London Borough of Lewisham

Local Impact Report

Thames Tideway Tunnel

**Submission Reference: LBLew05
Unique Reference Number: 10018610
National Infrastructure Directorate Project Ref: WW010001**

Photo 1 below shows the existing mature tree on Croft Street that would be lost if a vehicular access was created in this location

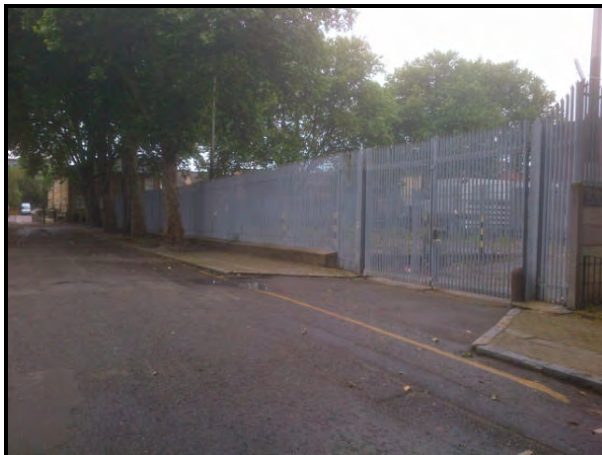
- 8.1.18 The Illustrative Construction and Highway Plans show a temporary construction access and permanent access from Croft Street that would miss an existing mature London Plane tree that is close to the boundary with No. 62 Croft Street (this tree is identified on the 'As Existing Site Features Plan' (DCO-PP-21X-EARPS-220002). See photo 1 in Annex 3.

- 8.1.19 However, the Access Plan (Drawing DCO-PP-21X-EARPS-220003) (For Approval) would allow for temporary and permanent access to be created along a defined length of Croft Street that includes the stretch where this existing tree is. In the Council's opinion this plan should be revised to prohibit the creation of a temporary or permanent access along the southern most 10m length of the site, up to the boundary with No. 62 Croft Street.

Photo 2 shows other mature trees on Croft Street that need protection during construction works.

- 8.1.21 ***As the DCO is currently drafted the local impact is likely to be negative.*** With adequate tree protection measures, by way of new Requirements, and an amended Drawing DCO-PP-21X-EARPS-220003, to show vehicle access avoiding all street trees, ***the local impact is likely to be neutral.***
